Addendum # 5
San Mateo County Harbor District
(Pillar Point Harbor RV Park Restroom and Greenspace Project)
(July 25, 2022)
IFB No.- 2018-08

Below are our responses to questions received as of July 25, 2022. New questions and responses begin at 5-1 through 5-5.

3

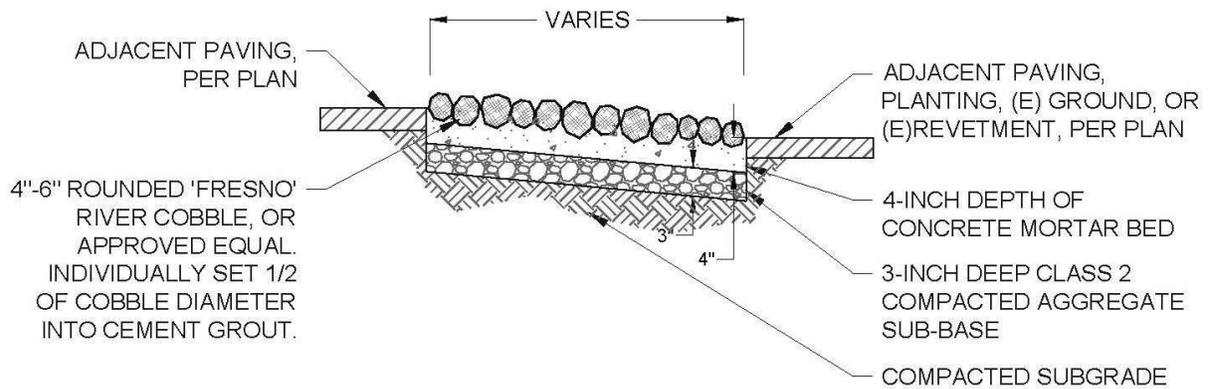
| 5-1 | Please provide detail for cobble per bid item no. 18 & 19. There are no details or depths for the requirements of base rock, cobble, or mortar.

A: Grouted Cobblestone Detail . The Landscape Legend and Details, Sheet 23, should be corrected as follows: <ul style="list-style-type: none">• Detail 3 Should be labeled "Grouted Cobble". This is the detail to be used for Bid Items 18 and 19:
Cobblestone Divider at Benches and Cobblestone Trail Collar and where shown on Plans. See Revised Detail 3 below.• Detail 4 Should be labeled "Boulder Installation" | Specs | Bid Form |

1. PLACE COBBLES WITH LONG DIMENSION ORIENTED VERTICALLY.
2. CROWN TO BE ROUNDED WITH NO SHARP GRADE BREAKS.
3. MINIMIZE VISIBLE EXPOSED GROUT AT COBBLE JOINTS.
4. SURFACE OF COBBLE FIELD TO BE SMOOTH AND FLAT TO GRADE WITHOUT VARIATION IN HEIGHT OF INDIVIDUAL COBBLES.
5. COBBLES WITH BREAKS OR FRACTURES ARE NOT ALLOWED.
6. ROCK SHALL BE 'SATURATED SURFACE MOIST' (SSM) PRIOR TO PLACEMENT.
7. CONCRETE MORTAR BED SHALL HAVE A CEMENT RATION PER CUBIC YARD OF CONCRETE OF NOT LESS THAN 564 POUNDS; SLUMP MAX OF 3"; AGGREGATE SIZE $\frac{1}{4}$ " MAXIMUM.
8. INTEGRAL COLOR ADMIXTURE: CHROMIX, ADOBE TAN, #C-21 BY L.M. SCOFIELD.

Sheet L-4

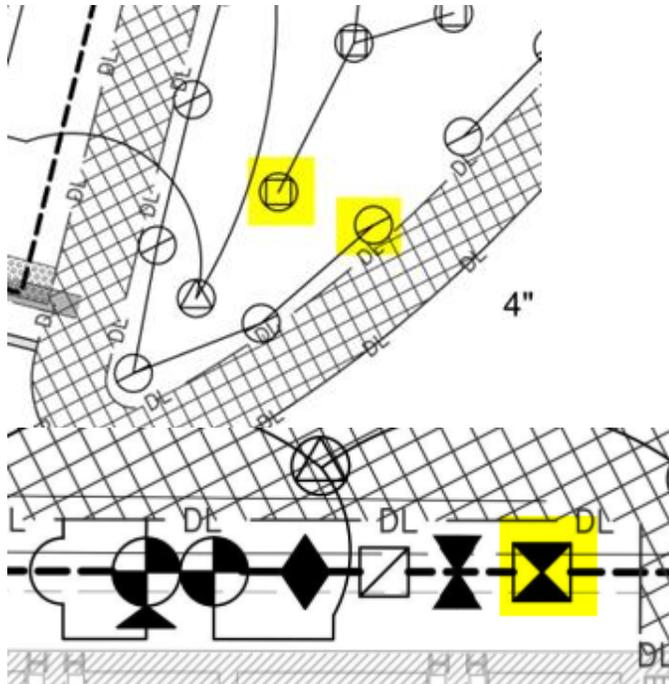
There are symbols highlighted in yellow below on sheet L-4 that is not identified on the legend. Please advise.

A: The irrigation circle with square or dash within is Detail 5, Irrigation Details Sheet 25, Pop Up Spray Head. a Hunter pop up spray, up to 15' radius @ 40 psi: PROS-06-PRS30-CV/MP815 FULL (CIRCLE WITH SQUARE), HALF (CIRCLE WITH A DASH). Install per details and manufacturers recommendations and adjust radius in field to avoid overspray.

The square checked symbol is the Backflow Prevention Device, Bid Item 42, however, not to be installed at the location shown on plans, but at the location of the new Irrigation Meter, see Sheet U-1 Utility Plan for correct location. Backflow Prevention Device and meter to be installed per CCWD requirements.
